DATE: March 4, 2011

REVIEW TYPE: Preliminary Plan of Subdivision

PROJECT NAME: Cedar Knolls Farm

CASE #: 120100050

Preliminary Plan Drawing

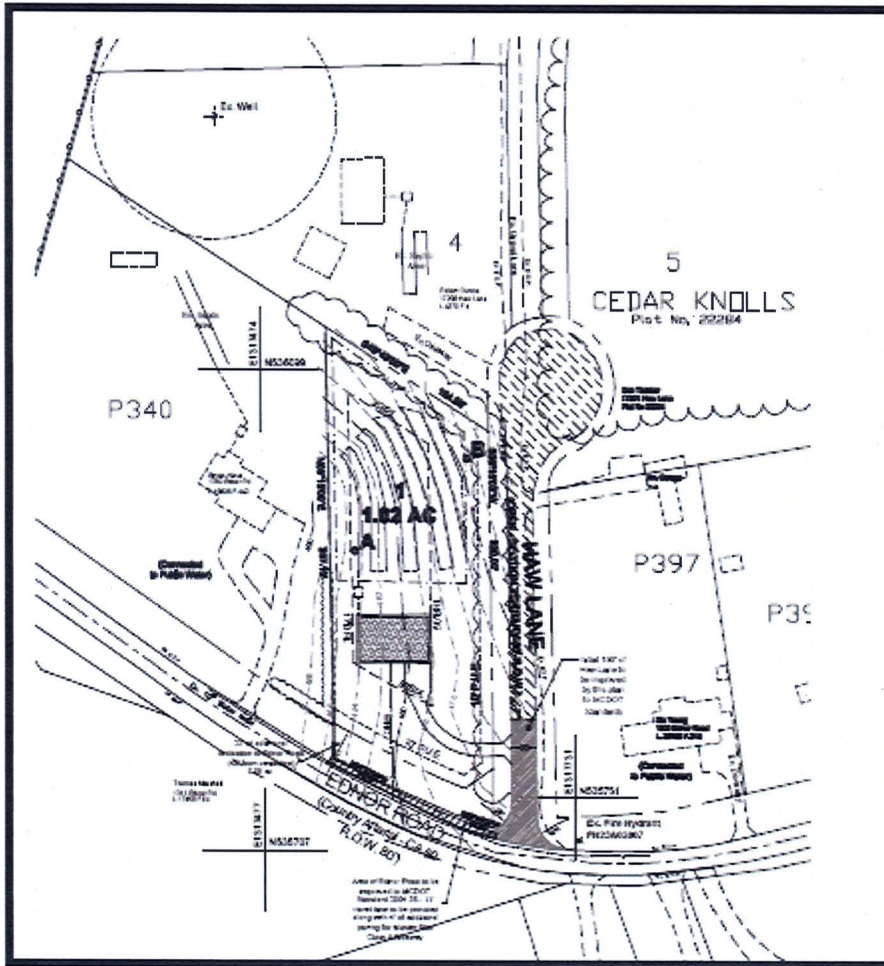
- 1) Approval under this preliminary plan is limited to one residential lot.
- 2) The record plat must show dedication along Ednor Lane 40 feet from centerline as shown on the preliminary plan drawing.

- 8) A note on the record plat to read, "Access Denied to Ednor Road" along Ednor Road frontage.
- 9) The record plat must show necessary easements.
